# **Haweswater Aqueduct Resilience Programme (HARP): Proposed Marl Hill and Newton-in-Bowland Compound Accesses**

Marl Hill and Newton-in-Bowland Road Safety Audit Stage 1 - Addendum

B27070EP - Marl Hill and Newton-in-Bowland compound access-RSA1 | P01

Figure 3 Proposed locations of speed cushion

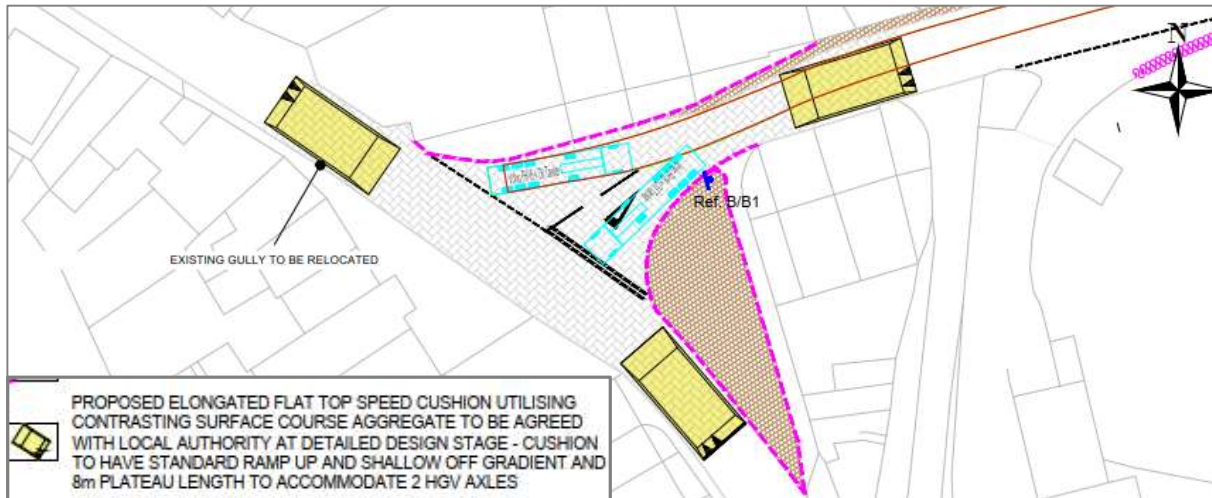
**Location:** Approaches to the priority junction at the Higher Buck between West Bradford Road and the B6478.

**Summary:** Profile of traffic control measure (speed cushions) may not be suitable for HGV turning and could possibly up settle and loose the load into the carriageway and footway in direct conflict with other road users.

As per drawing no. B27070CQ-JAC-XX-DR-C-TR4\_WV-1110 elongated flat top speed cushions are proposed on the approaches to the priority junction at the Higher Buck between West Bradford Road and the B6478. It is proposed that the cushions will have a standard ramp up and shallow off gradient and 8m plateau length to accommodate 2 HGV axles. Based on the traffic management plan (Document Reference: 80061155-01-UU-TR4-XX-RP-C-00024 Jan 23) provided to the RSA team, the following HGV types will be in operation within the scheme extent:

In addition to above, there will be abnormal load movements. As such the proposed speed cushions might not accommodate all sizes of vehicles within the scheme extents. Speed cushions that have inappropriate profiles may cause HGV instability resulting in the load shifting with the risk of the load or part of the load falling from the vehicle into the road or footway and injuring other road users.

Ensure that all speed cushions have an appropriate profile that can accommodate all sizes of vehicles.

**Figure B-1 General Arrangement Drawing- Problem Location**

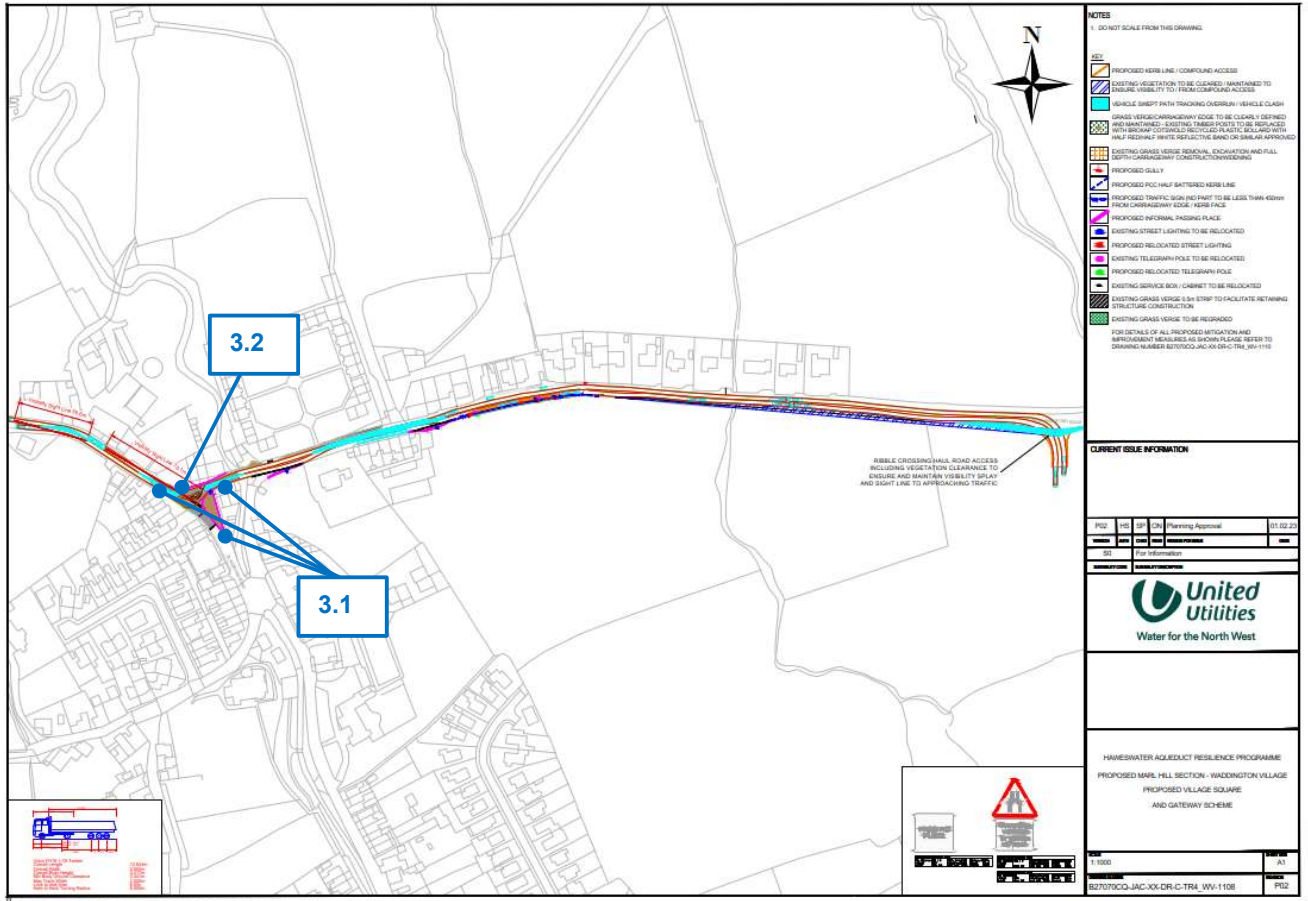
RSA team has observed that the Higher Buck outside sitting area is very close to the carriageway. There is risk that vehicles travelling southeast to east (West Bradford Road) unintentionally overrun the sitting area, potentially resulting in vehicle to pedestrian conflicts and causing serious injuries to pedestrians. The risk is exacerbated by the sharp turn at this location.

It is recommended to build out this seating area to maximise the distance between main carriageway and the sitting area.
